HISTORIC AND DESIGN REVIEW COMMISSION

August 16, 2017

HDRC CASE NO: 2017-420
ADDRESS: 2136 W SUMMIT
LEGAL DESCRIPTION: NCB 6826 BLK 0 LOT 9&10
ZONING: R-6 H
CITY COUNCIL DIST.: 7
DISTRICT: Monticello Park Historic District
APPLICANT: Gary Perkins
OWNER: Gary Perkins
TYPE OF WORK: Reconstruct porte-cochere
REQUEST:

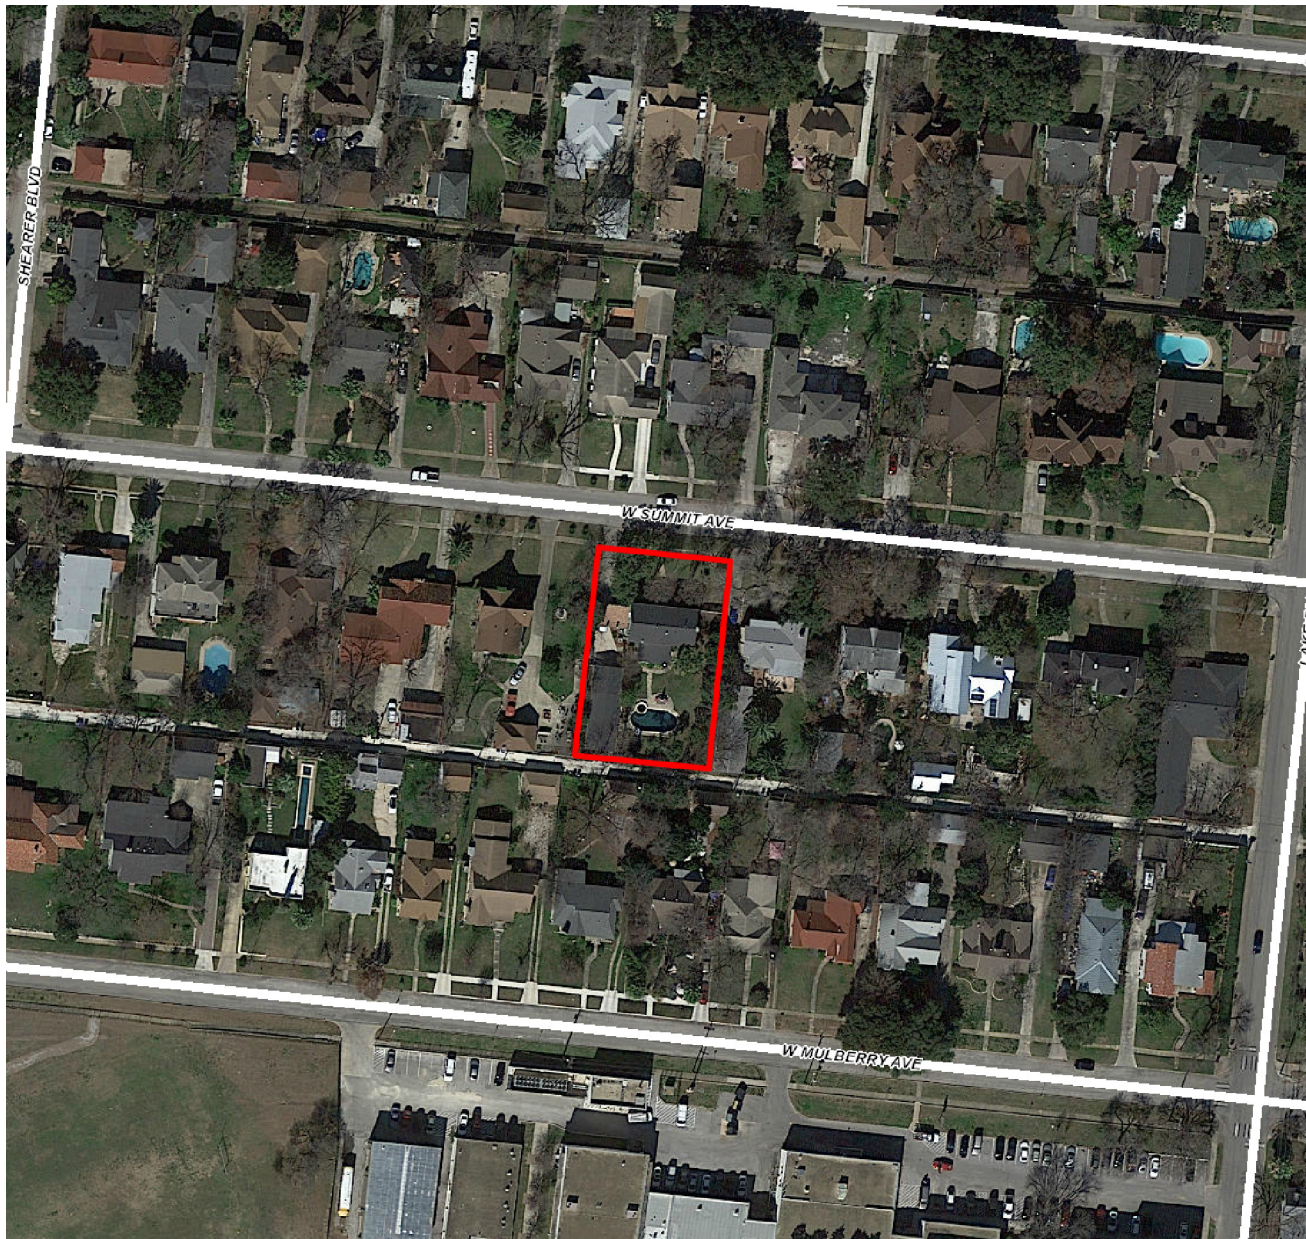
- b. **PORTE-COCHERE** – The existing porte-cochere is constructed of wood structural members and clad in stucco. The second story terrace features stucco-clad square pillars, a low wrought iron fence, and a tiled deck. The porte-cochere is supported by simple square wooden posts. The structure, along with the 1-story portion of the home to which it is structurally affixed, is not original to the historic structure. According to a 1950 Sanborn Map, the footprint of the original home is confined to the 2-story structure. The side addition and porte-cochere were added

sometime after 1951. The structural elements of this addition are currently failing. The wooden beams supporting the porte-cochere decking are rotting and bowing from water infiltration, which is causing the exterior stucco to shed from the siding and expose additional interior structural elements, like wall studs. The interior wall of the 1-story side addition is also experiencing water infiltration from the shifting beams, which has resulted in interior damage and flooding. Based on these urgent considerations, the applicant received administrative approval to begin demolishing the structure.

- c. RECONSTRUCTION – The applicant has proposed to reconstruct the porte-cochere mostly in-kind. The wrought iron fencing will be retained and the stucco columns will be reconstructed to match the existing. The tile decking will be replaced with treated cedar beams. The new structure will incorporate a drainage system under the deck and a gutter to direct rain away from the structure. The brick masonry detail above the 1-story addition will be replaced with an LVL supporting beam to be painted white. Based on the fact that the porte-cochere and 1-story element of the home are non-original to the historic structure, staff finds the proposed modifications and reconstruction strategy appropriate for the style of the home.

Staff recommends approval based on findings a through c with the stipulation that the applicant submits final drawings to staff for approval.
